June 3, 2021

Brian Teles, Project Manager
Ronald Young, District Press Officer
PennDOT District 5-0
1002 Hamilton St
Allentown, PA 18101

Hill-to-Hill Bridge Comments for Bicycling, Pedestrians, and Trails

Figure 1-Existing Bridge Lane/Sidewalk Configuration (PennDOT)

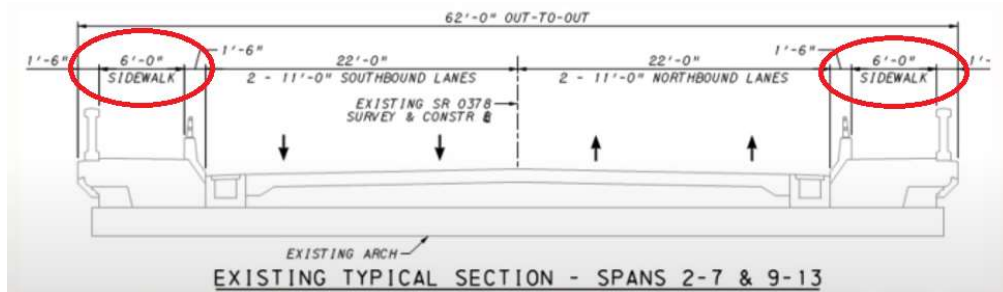
The existing 6'-0" sidewalks provide access but are cramped and awkward when pedestrian volumes are high or when bicyclists are present. Pedestrian visibility is restricted at the Brighton Street crosswalk. In the existing configuration, bicyclists should walk their bikes on the sidewalk due to tight space and low railings.

Figure 2-Design Alternative 2E

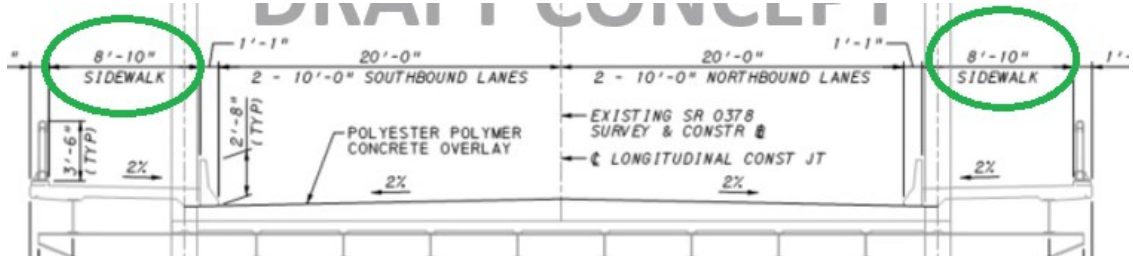
- Alternative 2E extends both sidewalks from 6'-0" to 8'-10".

Figure 3-Design Alternative 3B

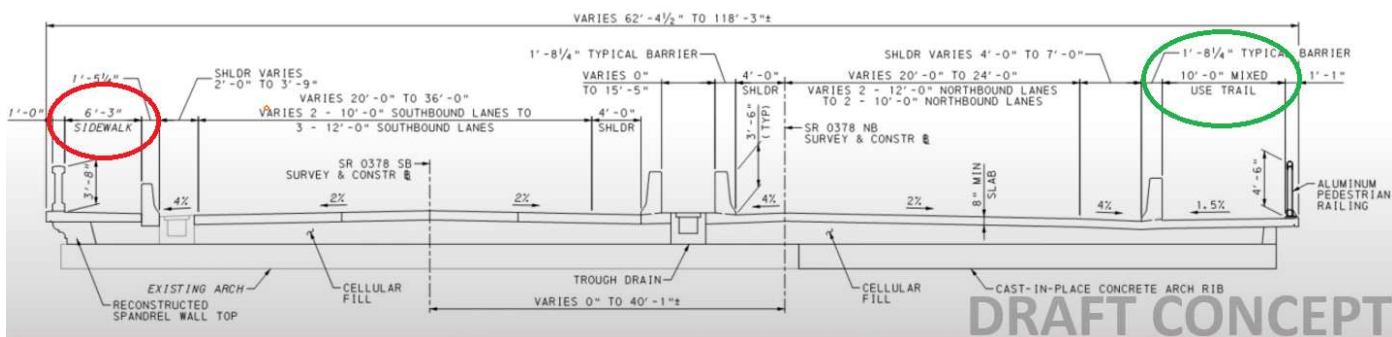
- Alternative 3B extends the eastern sidewalk from 6' to 10' which creates an excellent mixed-use path though it keeps the western sidewalk 6'-3". **CAT would like to know that if Alternative 3B is chosen, could the western sidewalk also be widened to 10'?**

Figure 4-Design Alternative 5B

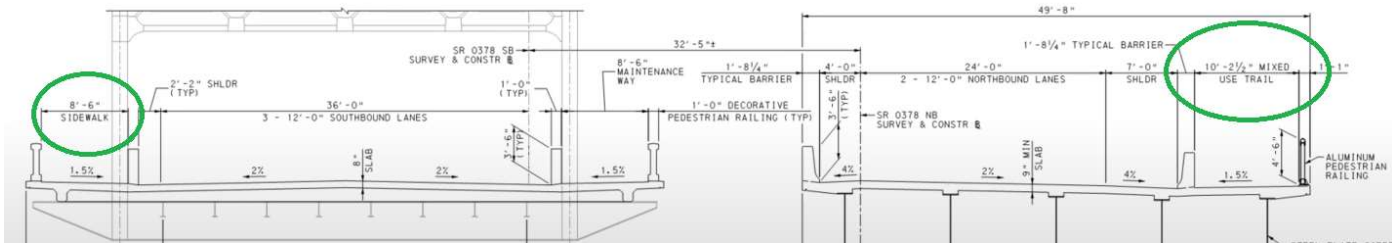
- Alternative 5B includes building an entirely new span next to the current one. expanding the 6'3" western sidewalk to 8'6" and the eastern sidewalk to 10' as a mixed-use trail. The inclusion of the 10' mixed-use trail is very appealing, though we await more detail on crosswalks, intersections, and connection to the Southside Bethlehem Greenway (more in item 4 below).

Figure 5-Potential Trail Connector to Southside Bethlehem Greenway

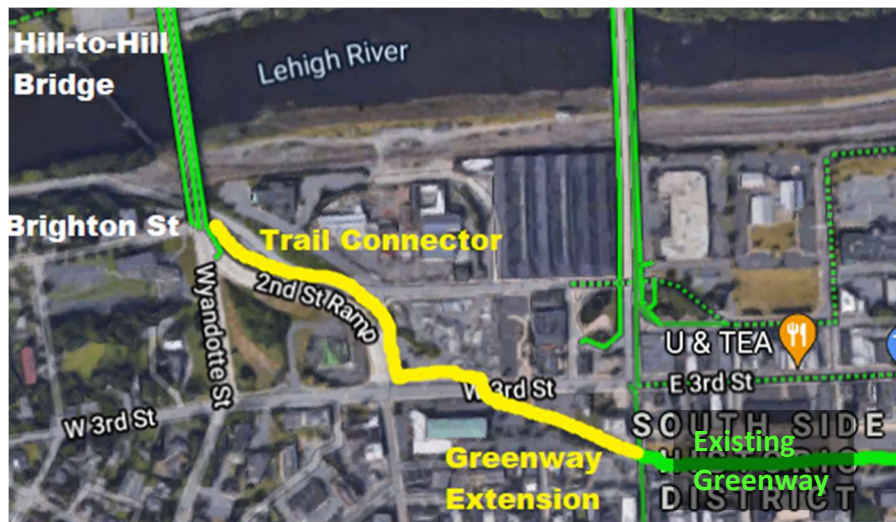
Another connection that would be very synergistic would be the Hill-to-Hill bridge to the Southside Bethlehem Greenway at W 3rd Street. A logical trail crossing location would be next to Comfort Suites hotel with a dedicated crosswalk. This connection might continue along the 2nd Street ramp. This would very much bolster the city of Bethlehem's trail network. People walking, rolling (wheelchair), or bicycling - from the Southside Bethlehem Greenway across the eastern sidewalk of the Hill-to-Hill Bridge could easily connect to the D&L Trail at Sand Island.

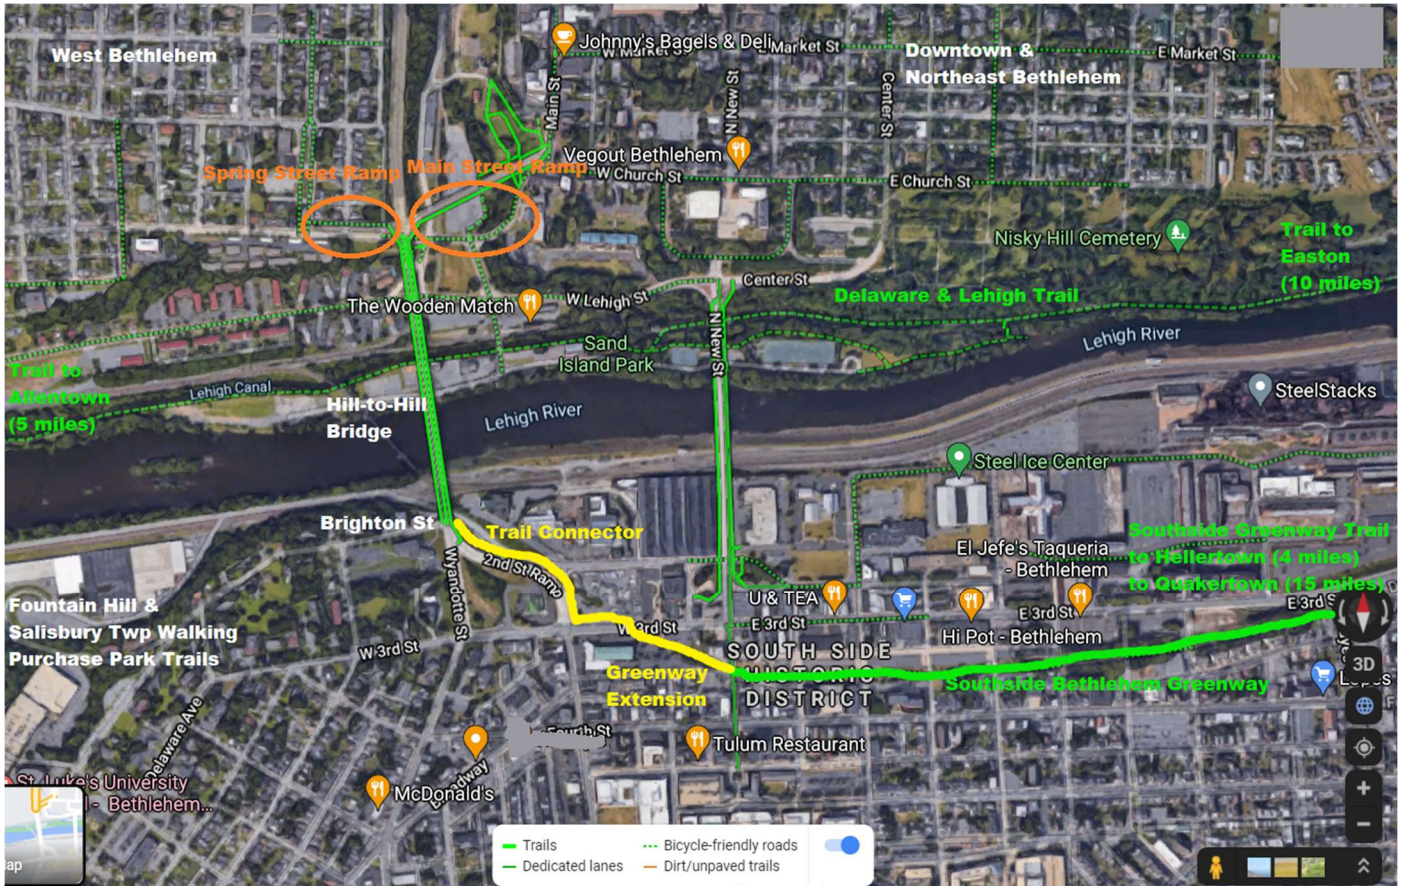
We are very keen to see well-signalized crosswalks at the south end of the bridge:

- SR378 @ 2nd Street ramp
- 2nd Street ramp @ SR378
- Brighton St @ SR378
- Southside Bethlehem Greenway @ 2nd St ramp

At the north end of the bridge:

- Pedestrian access maintained at Spring St ramp
- Pedestrian access maintained at Main St ramp and stairs to Conestoga St
- Trail connection to D&L Trail @ Sand Island
